DVOR Rationalisation Removal of Enroute Dependencies Trent (TNT) Deployment

DVOR TNT Holds and STARs

Reference 5: Stakeholder Evidence for Stage 2 As summarised in Annex H of Stage 2 Documentation

Existing

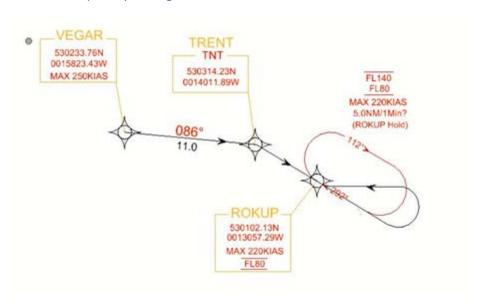
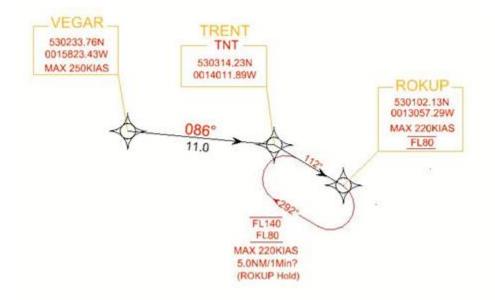
Kind regards
Alana da Marana da M
Air Navigation Services Manager
East Midlands Airport
Castle Donington
DE74 2SA
2. Email trail with East Midlands Airport to discuss ROKUP/DIPSO Hold options
2. Linai traii with Last Widanus Airport to discuss Nokor/Dir 30 Hold options
France
From: Sent: 26 February 2021 10:12
To:
Cc:
Subject: RE: TNT DVOR Replication
Hi la control of the
Hope you are well .
A couple of questions around the ROKUP hold.
The existing entry via DIPSO is quite convoluted and entry could be shortened (subject to CAA
approval within the spirit of replication)

If the teardrop entry through ROKUP was utilised would this cause issues?

The other option not shown would be to use DIPSO as the hold with distance or time based as this will also generate enable fuel savings and remove reference to ROKUP. However, I'm aware that you have non radar procedures based on the current holds and but would need to be amended either in chart form and/or textual. In addition I presume an EFPS update may be required?

The other argument is holding is relatively rare at ROKUP and mainly confined to the evening arrivals on rare occasions (You did hold recently when I was on an afternoon shift after my nice streaming but you did go into LVPs' at the wrong time!)

Sent: 15 March 2021 11:46
To: Cc:
Subject: RE: TNT DVOR Replication
Hi
Good to hear from you.
I'll start off by saying that the option for DIPSO is a non-starter as it will involve major work on our EFPS and this will be timely and costly and so there is no appetite for that at present. That will obviously change once we re-start our ACP at some point.
With regards to the other options, it would be good to see what quantifiable difference this would make to our operators. As you say, the holds are very rarely used and so I am of the opinion to leave them be at present and again see where we are with the ACP.
Kind regards
Air Navigation Services Manager
East Midlands Airport
Castle Donington
DE74 2SA
Tel:
Mob:
